## **SUMMARY**

This report concerns the amended plans and additional information submitted to Council on 22 April 2021 and 27 May 2021 for an application to construct an 8-storey mixed-use development comprising ground level retail, 57 residential units, three levels of basement car parking and a pocket park. The amended plans and additional information were submitted in response to the resolution of the Sydney Eastern City Planning Panel (SECPP) at its meeting on 1 April 2021.

The revised application is now referred to the SECPP for determination.

Figure 4: Revised perspectives of privacy treatments to levels 03 – 05.

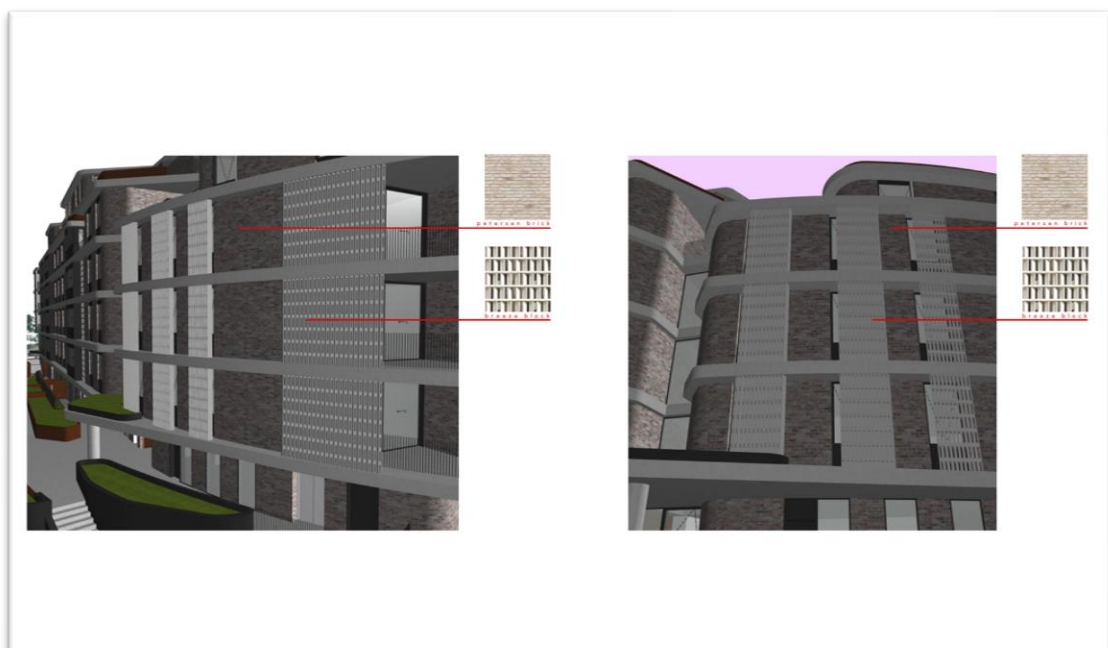
As seen within figure 4 above the applicant has provided a revised privacy screen design for units located upon level 01 to 05 within the north east corner of the site. This revised privacy screen design extends over proposed windows and a portion of the proposed balconies which have the greatest potential privacy impacts for the residents of 14 McGill Street. This revised privacy treatment design ensures opportunities for light and ventilation into the proposed units, while also minimising opportunities for direct sightlines between neighbors. The screens have been designed to blend and contribute to the façade of the development and will not form a detracting element in the final public presentation of the building. The proposed revised privacy treatments are acceptable and recommended for support.

*Figure 5: East Elevation – Extent of built form hidden from public domain or neighboring perspectives outlined by red dashed box.*

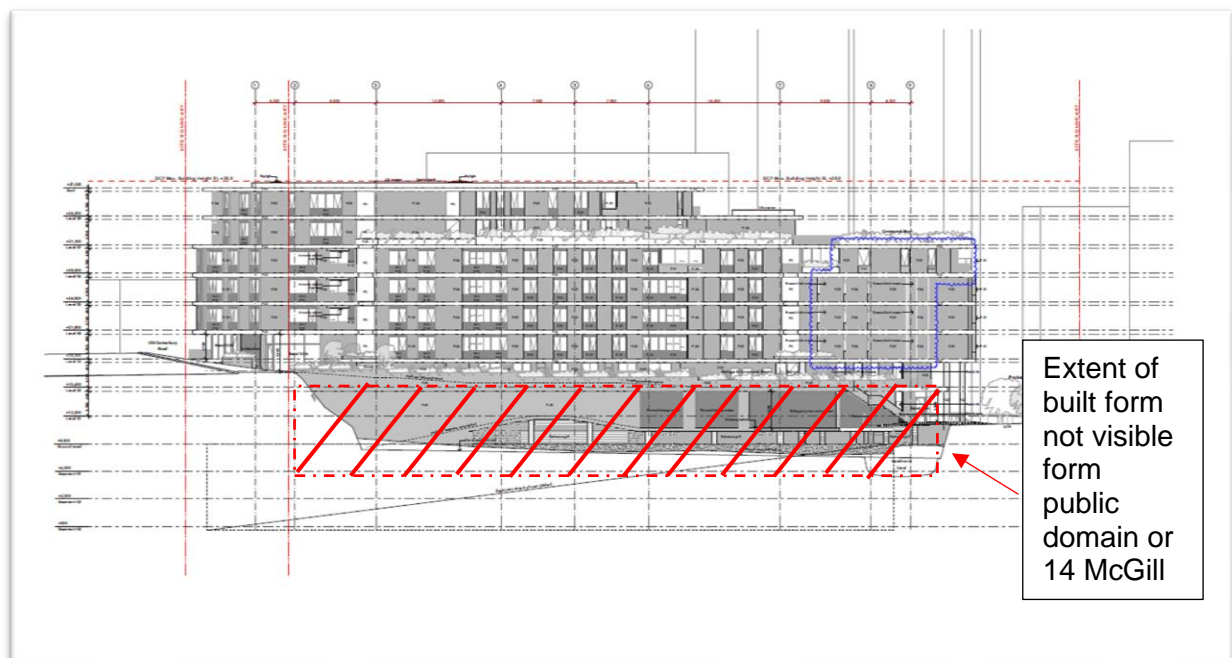
The Panel will note that Council's previous assessment report outlined that levels 05 and 06 were non-compliant with the minimum separation distance of 9m. As part of the additional information package provided by the applicant a justification for the reduced setback to level 05 has been provided. This justification argues satisfactorily that due to the slope of the site and design of neighbouring development that level 05 will be perceived as level 04 from the public domain (through-site link) and the neighboring 14 McGill Street.

In this instance, the areas below the through-site link (basement entry) are not readily registerable and as such do not substantially contribute to the bulk and scale of the development. This is best illustrated in figures 5, 6 and 7 below. It is therefore unnecessary to require level 05 to be setback an additional 1.5m, as it will only be viewed as level 04 from all neighboring vantage points. It is therefore recommended that level 05 be assessed on a site-specific basis and in this instance be treated as a level 04, which would only require a 6m setback from the center of Hawthorne Canal.

*Figure 8: – Model of built form envelope approved under planning proposal (bottom image) & – Model of built form envelope proposed under current development application (top image)*

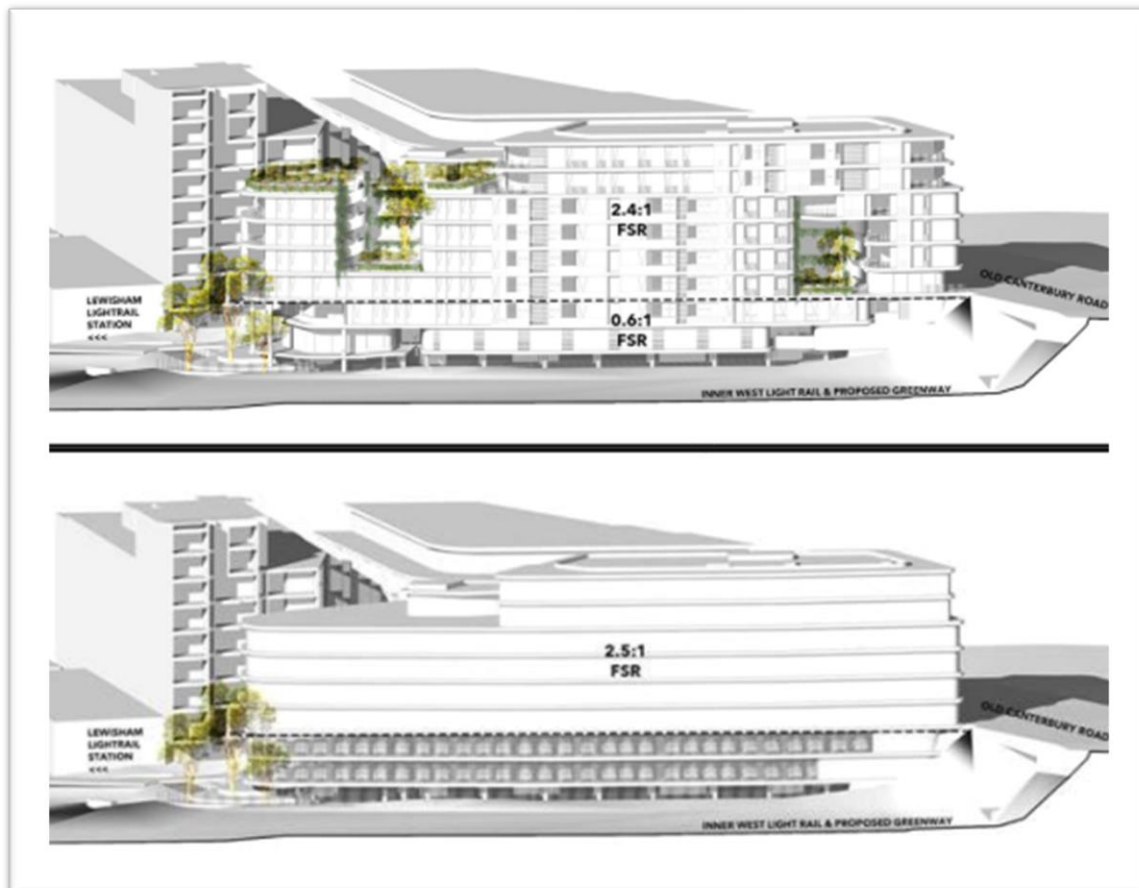
The applicant seeks a variation to the Floor Space Ratio (FSR) development standard under Clause 4.4 of the ALEP 2013 by 20% (979 sqm). This variation to FSR is directly attributed to the lower two levels of the development, which under the planning proposal were designated to cater for above-ground car parking. Since the time of the planning proposal the application

has been amended (based on new flooding advice) and now incorporates basement car parking. The provision of basement car parking has enabled the creation of additional residential accommodation/retail spaces within levels 1 and 2, previously to be solely utilised for above-ground parking. The application has been amended since the Panel's 1 April 2021 meeting, with Level 01 plan (as seen within figure 1 above) now outlining the deletion of the three (3), two-bedroom units previously proposed. Instead, the amended plans detail this space being used for the provision of residential storage. This residential storage is not located within a basement and therefore continues to count towards overall FSR. The applicant has provided a revised clause 4.6 based on the amended plans. An assessment of this revised 4.6 is outlined below.
